Amendments to the Drawings

Please amend drawing sheets 1, 2, 4, 7, 9 and 11-15. For each sheet of drawings that has been amended, Applicant submits herewith a marked-up copy labeled as “Annotated Marked-Up Drawing Sheet” and a replacement sheet labeled as “Replacement Sheet.” All changes to the drawings are described in detail below.

Serial No. 10/775,943
Annotated Marked-Up
Drawing Sheet 1

Fig. 1

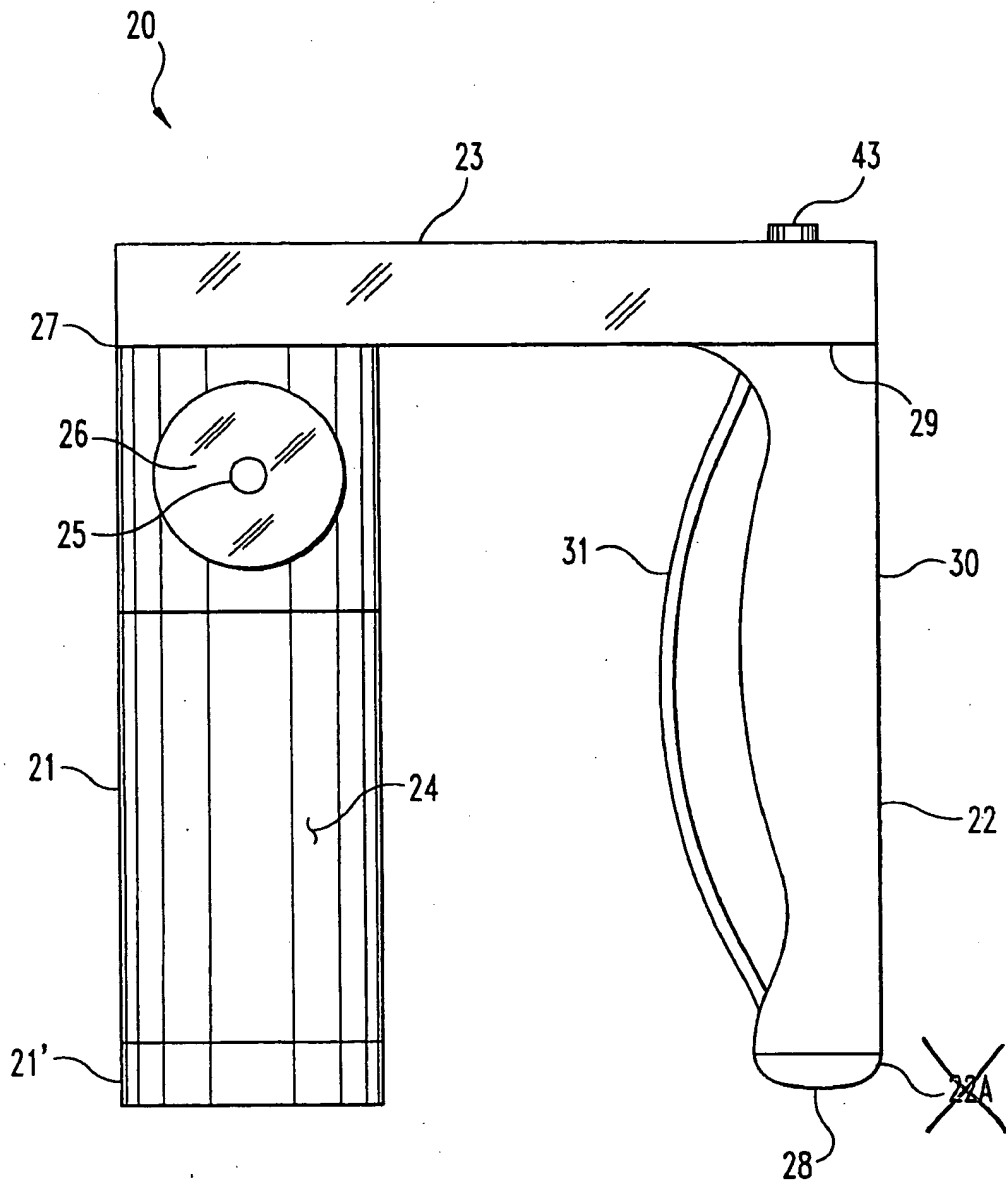
Sheet 1 – Fig. 1

Deleted the reference number 22A as 22A is referenced in the specification as the handle portion of the embodiment shown in Figs. 2A-C (See Appln, page 12, lines 21-23).

Fig. 2A

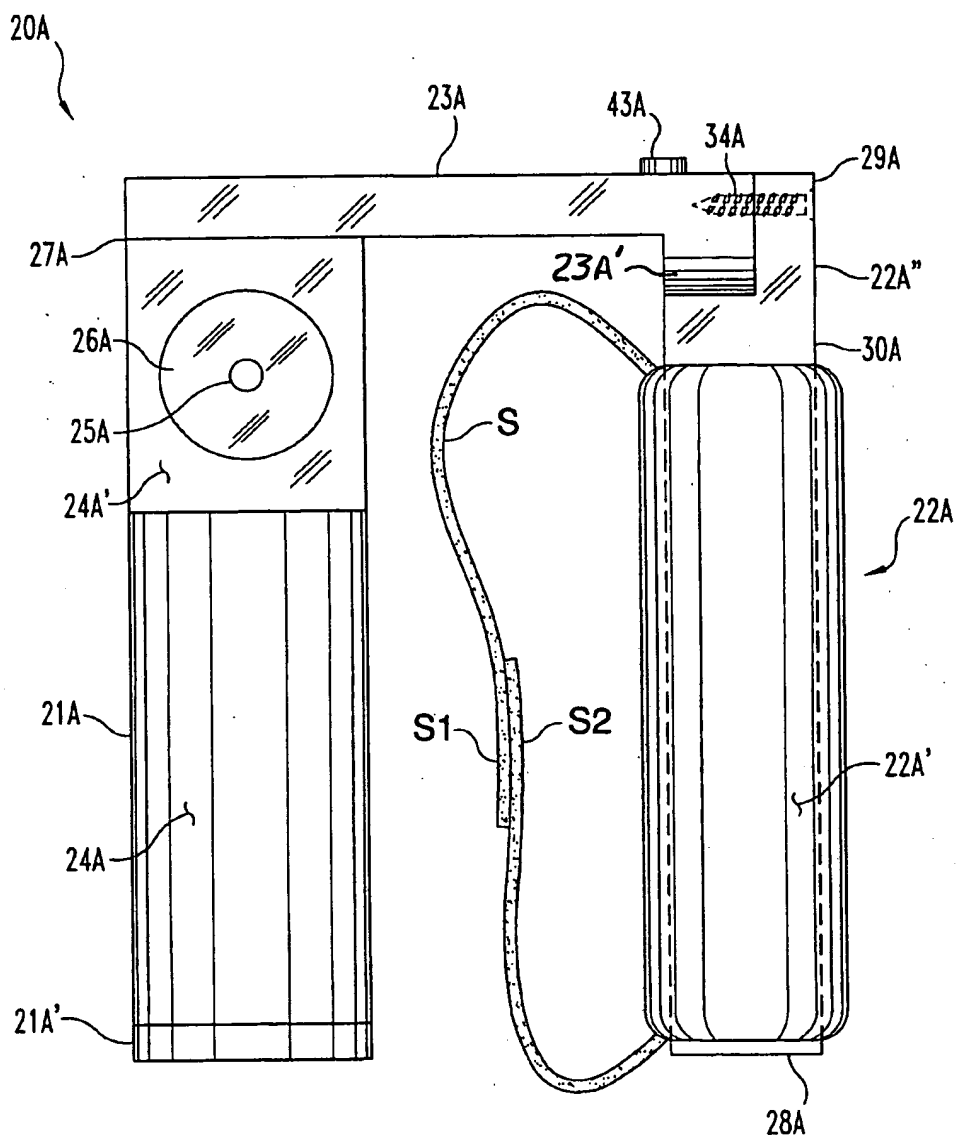
Sheet 2 – Fig. 2A

Added reference number 23A’ to indicate the downwardly depending leg (See Appln, page 13, lines 11-13).

Fig. 2D

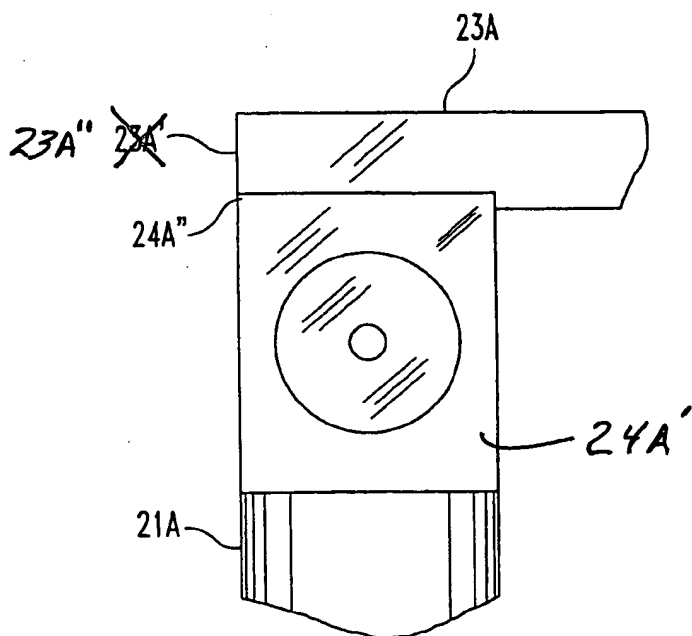
Sheet 4 – Figs. 2D and 2E

For each figure, added reference number 24A’ and replaced 23A’ with 23A” (See Appln, *revised* paragraph on page 14, lines 9-23). 23A’ is used to refer to downwardly depending leg on Figs. 2A and 2C, so 23A” is being substituted to refer to the rounded end of the transverse member 23A.

Fig. 4

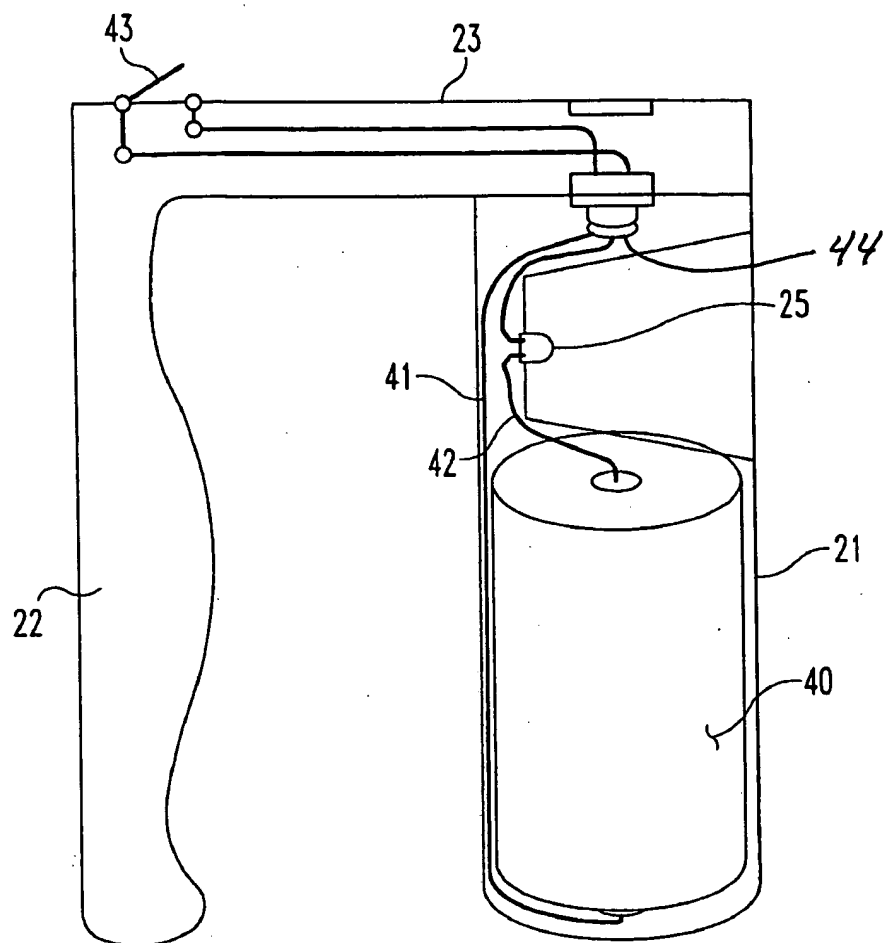
Sheet 7 – Fig. 4

Added reference number 44 to indicate the central channel extending between the lightbox 21 and the transverse member 23 for the leads (See Appln, page 15, lines 11-14).

Fig. 9A

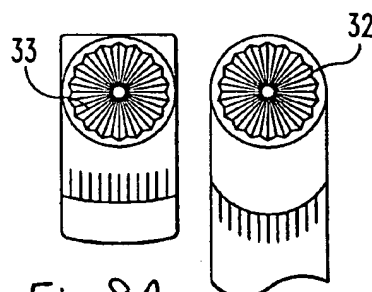
Sheet 9 – Fig. 9

Fig. 9 has been relabeled as Figs. 9A and 9B since they are two separate figures. (See Appln, *revised* paragraph on page 6, lines 8-12).

Fig. 12

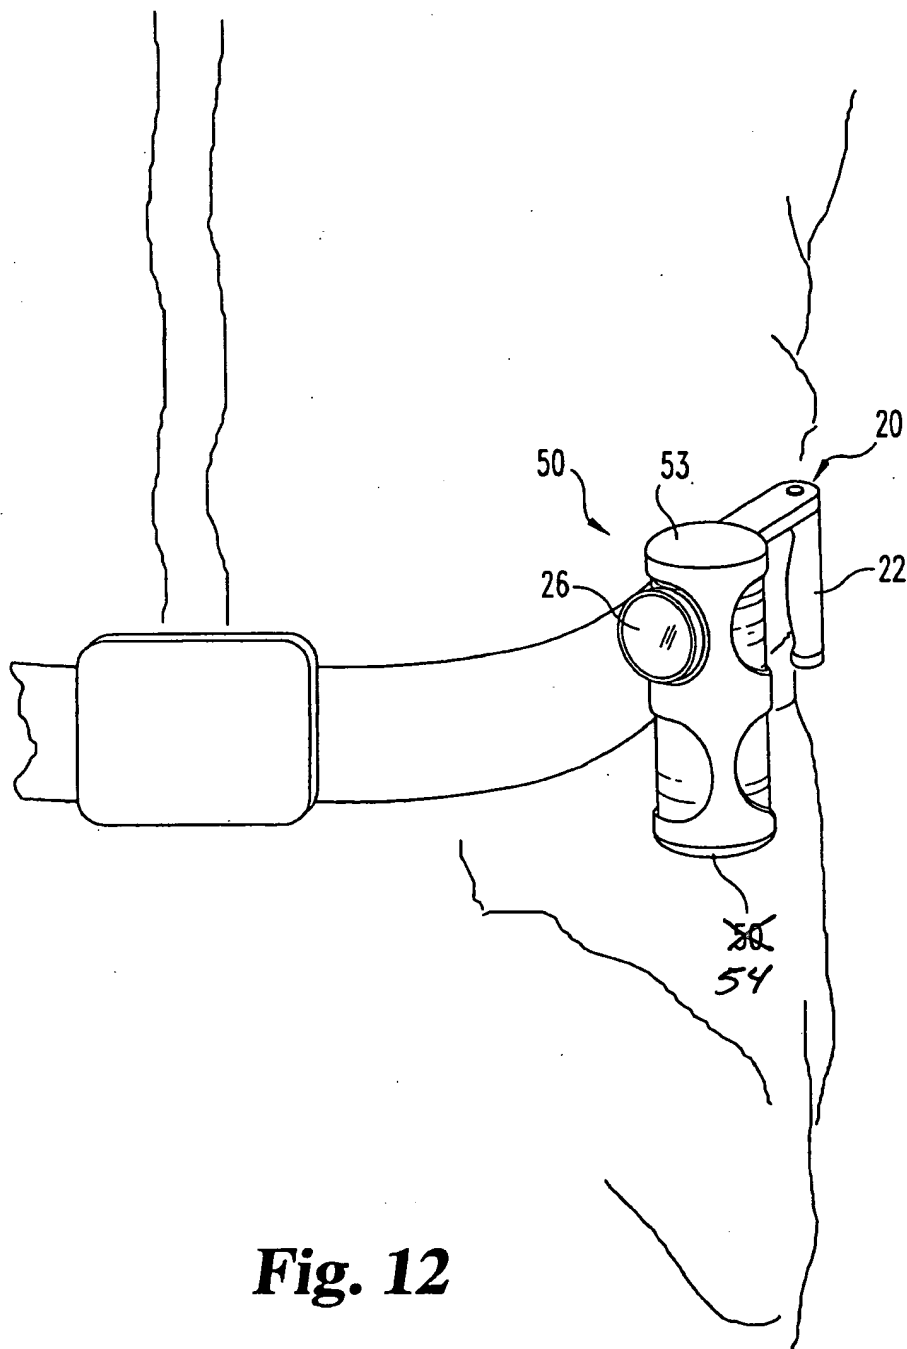
Sheet 11 – Fig. 12

Replaced the lower reference number 50 with 54 to indicate the holster end (See Appln, page 21, lines 9-13).

Fig. 13

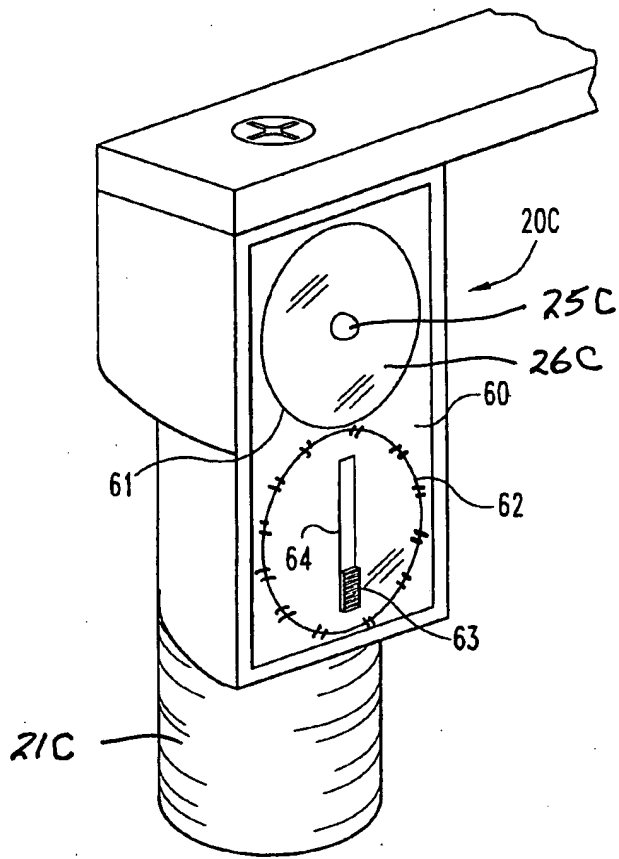
Sheet 12 – Figs. 13 and 14

In Fig. 13, added reference numbers 21C for the lightbox, 25C for the light source, and 26C for the lens, and revised red lens 62 to be shown in phantom as referenced in the specification (See Appln, page 23, lines 6-19). In Fig. 14, added reference numbers 20D for the flashlight embodiment and 21D for the lightbox as referenced in the specification (See Appln, page 24, lines 10-13).

Fig. 17

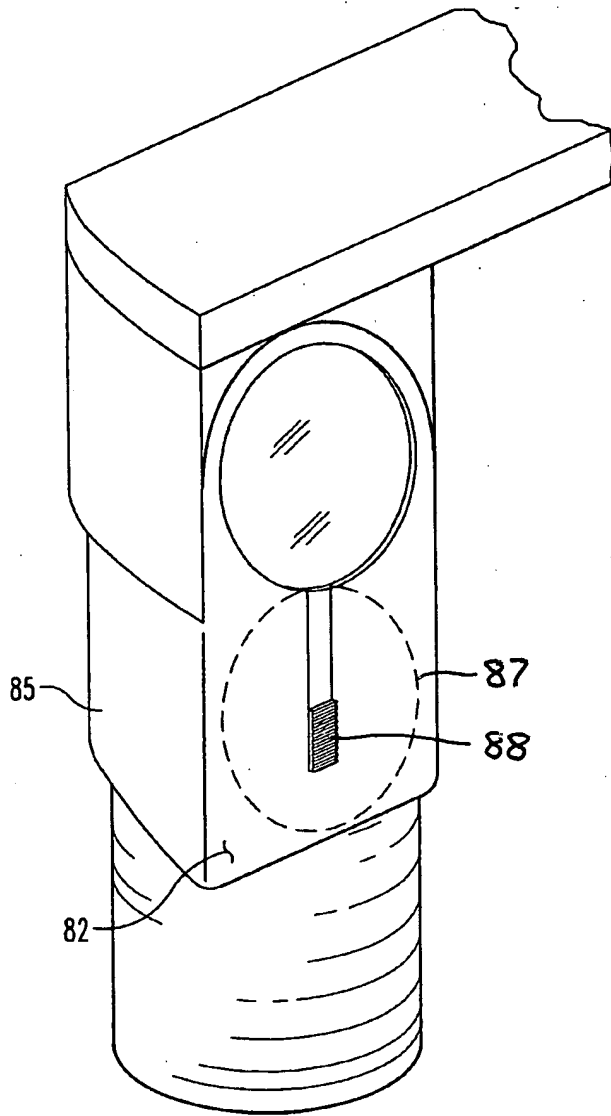
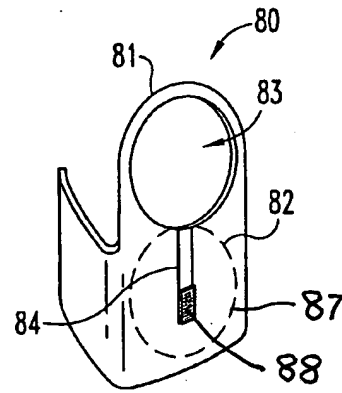
Sheet 13 – Figs. 16 and 17

In Figs. 16 and 17, added reference numbers 87 for the red lens and 88 for the slider member (See Appln, *revised* paragraph on page 25, lines 4-22).

Fig. 19

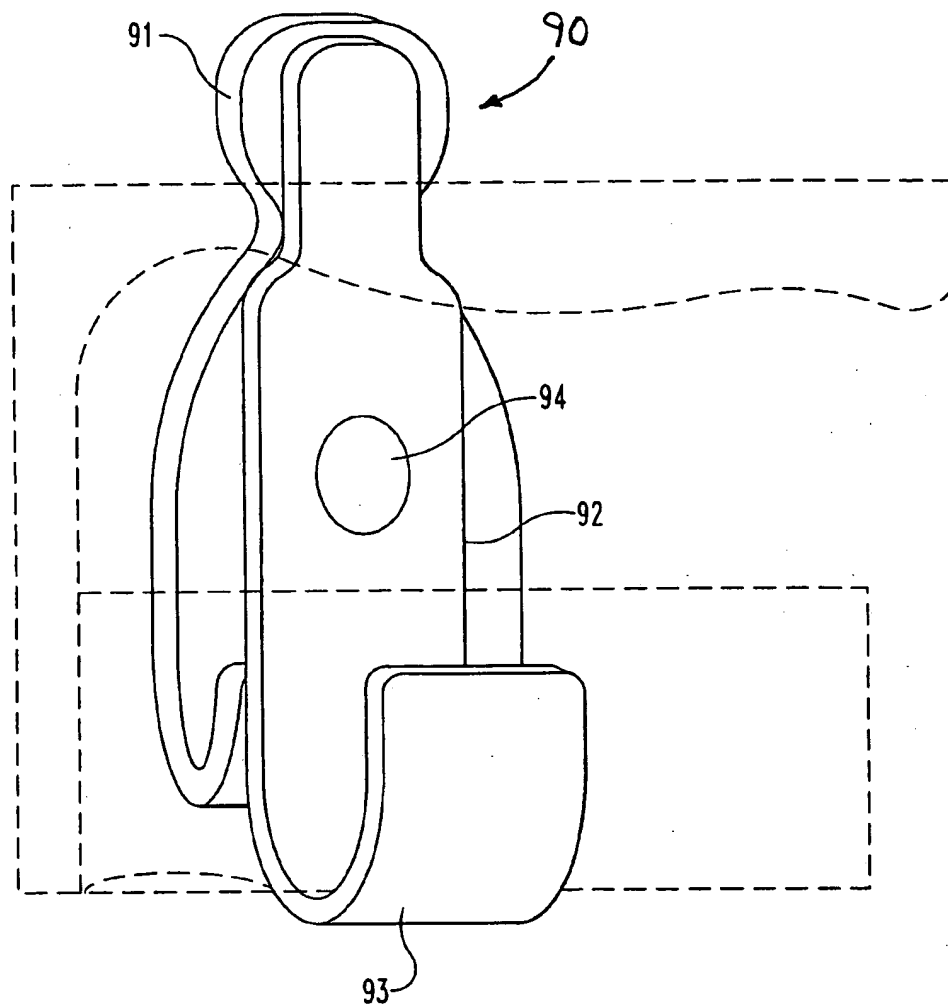
Sheet 14 – Fig. 19

Added reference number 90 for the holster appliance (See Appln, page 26, lines 1-3).

Fig. 20

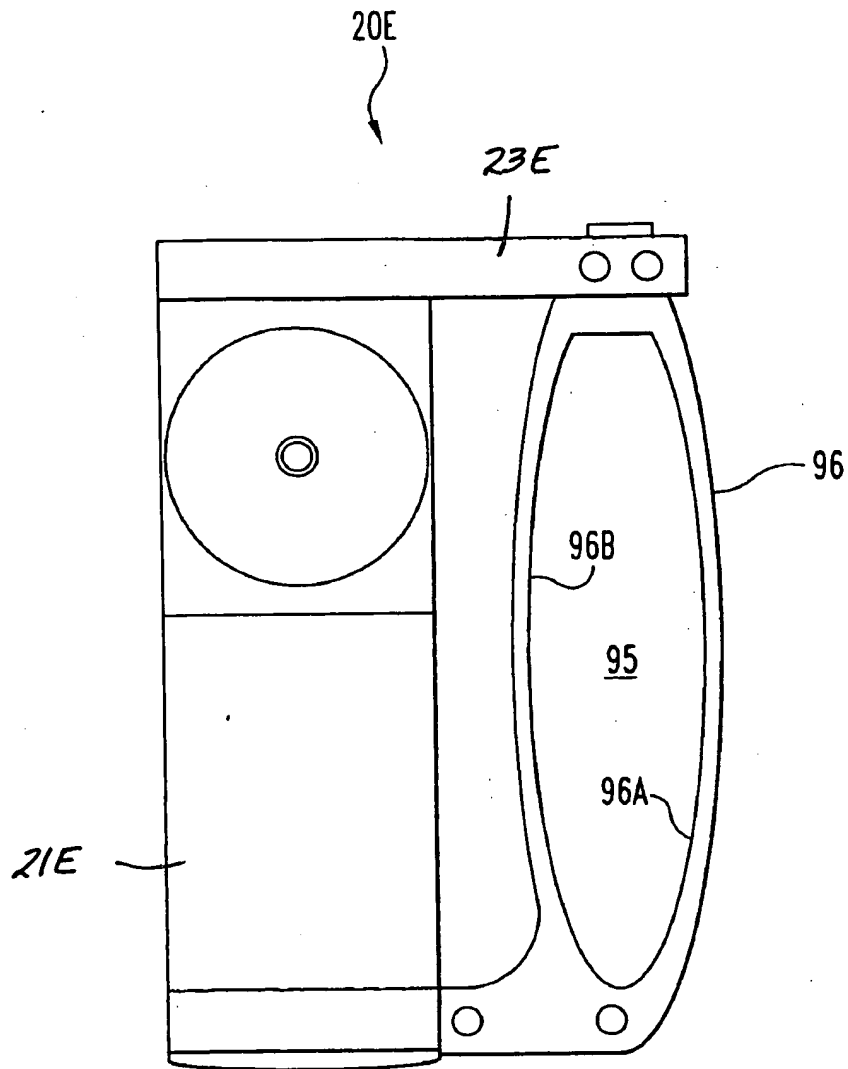
Sheet 15 – Fig. 20

Added reference numbers 21E for the lightbox and 23E for the transverse member (See Appln, page 27, lines 3-5).
